Delegated Report		Analysis sheet		Expiry Date:		01/01/2015	
		N/A / attached		Consultation Expiry Date:		None as AOD	
Officer				Application Number(s)			
Jonathan McClue				2014/6953/P			
Application Address				Drawing Numbers			
15 Highgate Road, London, NW5 1QX				Refer to Draft Decision Notice			
PO 3/4	Area Team Signature	C&UD	Authorised Officer Signature				
Proposal(s)							
Details relating to conditions 9 and 10 (details of cycle and refuse storage) of planning permission dated 30/03/12 (ref. 2011/3819/P) for the change of use of upper floors from ancillary restaurant accommodation (Class A3) to create three (2x2 and 1x3 bed) self-contained flats (Class C3) including rear (south) extensions at first and second floor level and roof extension to create new third floor level with external terrace areas and associated alterations including new entrance on Highgate Road (west) elevation.

Site Description

Figure 1: Sheffield Stand Elevation

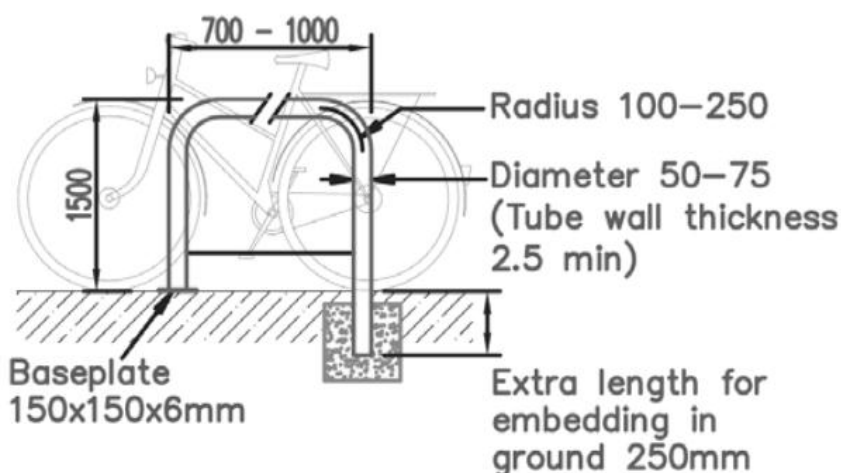
4.3 The types of stands are not specified within the submitted details and it is not possible to determine whether they meet the design specifications of figure 3, page 52 of CPG7. The 3 proposed stands in line with each other are placed at an angle and it is doubtful whether they could be used easily in practice. They do not provide an area of at least 1800mm by 500mm. Furthermore, all of the proposed stands are placed close to a wall and they are within 300mm of it. Therefore, they would also fail this requirement.
